Appendix B – Detailed Response to Submissions Table

These tables below provide a summary response to DPHI issues, Randwick Council and Government Agency submissions, as well as Public Submissions, and cross references where each issue is addressed in further detail in the Response to Submissions (RTS) report, prepared by Ethos Urban (now Colliers Urban Planning) .

1.1 Department of Planning, Housing and Infrastructure

Table 1 DPHI Matters

As exhibited

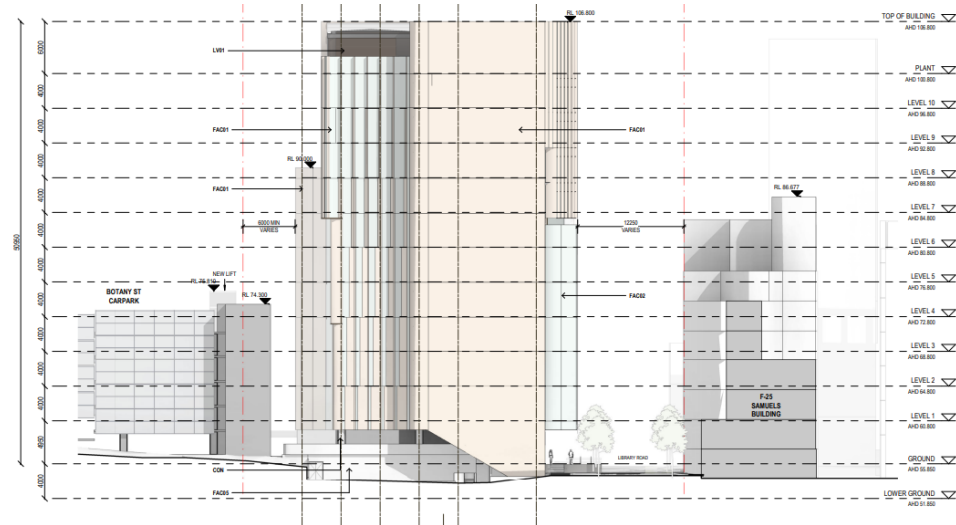
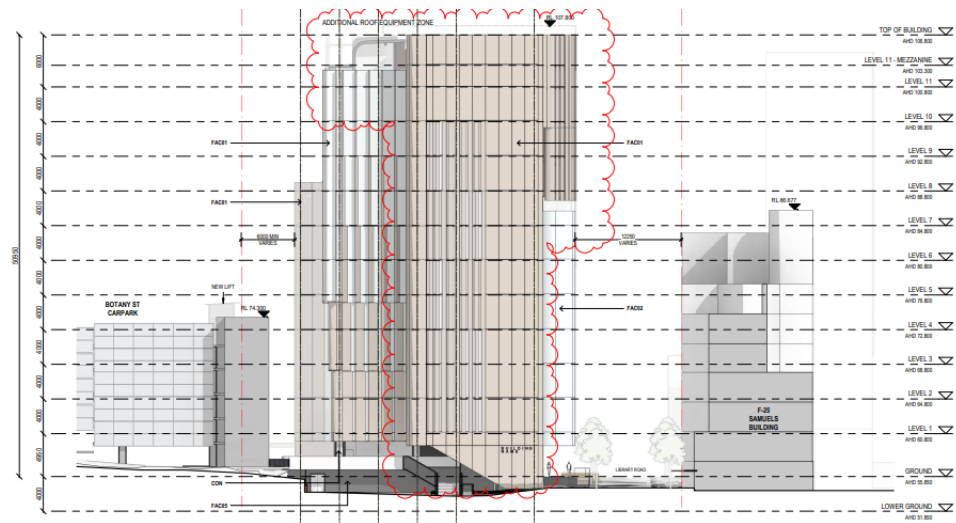
<p><i>Council is supportive of the design of the proposed façade and its seamless integration with the existing landscape, enhancing the built environment. To better integrate with the surrounding built environment, Council recommends that the east facing façade is better articulated on the black wall located between the two glass facades; this location could better accommodate artwork such as engraving that honours biophilic forms in the proposal's 'Key Themes' of the Design Report (Appendix E). This would provide greater visual interest for those entering from Gate 11 (Library Walk).</i></p>	<ul style="list-style-type: none">• Noted that Council supports the design of the façade and integration with landscaping.• Further development of the Eastern Facade and Elevation has been undertaken, reflecting refined panelling and articulation across the Eastern Stairwell. Material selection and colours of the facade have responded to the Community Engagement Feedback Process and Indigenous Design Principles developed with First Nations Design Consultant Yerrabingin. Connecting with Country principles including <i>Harmony with Nature</i>, have informed the warm colour selection, embracing natural elements and honour Country through colour, tone and form.• A comparison between the exhibited and amended East Elevation is shown below:

As proposed to be amended
